Likelihood and Reliability

Attachment 3

- Provide general response to RAI likelihood and reliability questions

Statistical Models

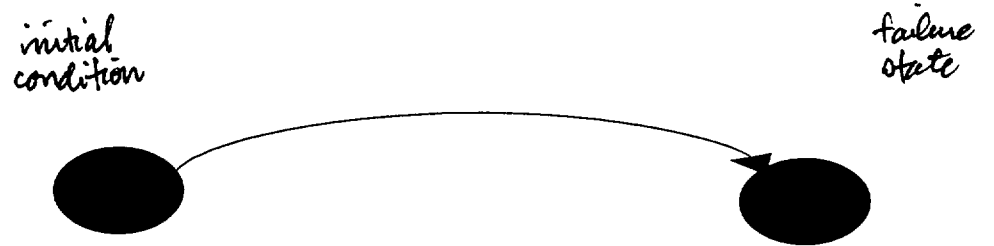
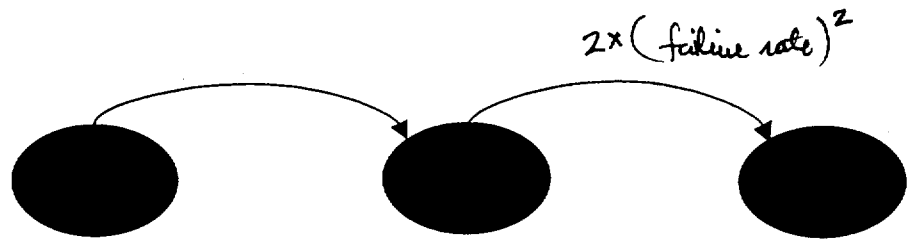
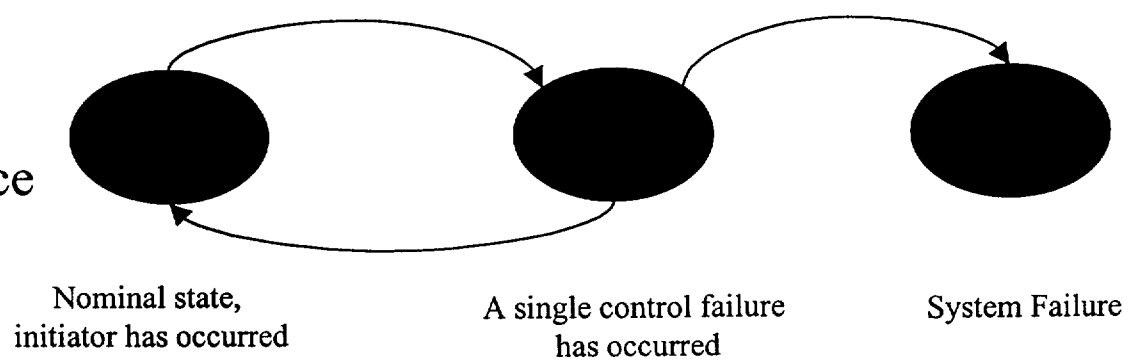
- Explain how the application of the single failure criteria or double contingency principle meets the performance criteria of 10CFR70.61
- Provide quantification of IROFS reliability or provide IROFS reliability targets

- Single Failure Criteria by itself may require rigorous reliability analysis to demonstrate Highly Unlikely Criteria is met
- However, Highly Unlikely Criteria is ~~easily~~ met with the application of the following:
 - Single Failure Criteria or double contingency principle
 - Management measures including IROFS Surveillance (IROFS failure detection and Repair or Process Shutdown)
 - 10CFR50 App B, NQA-1 QA Program *Such items are generally reliable to $< 10^{-2}$ failures per year.*
 - Industry Codes and Standards

Model 1:
Single Control Model

Model 2:
Single Failure Model
(double contingency model)

Model 3 (MFFF):
Single Failure and Surveillance
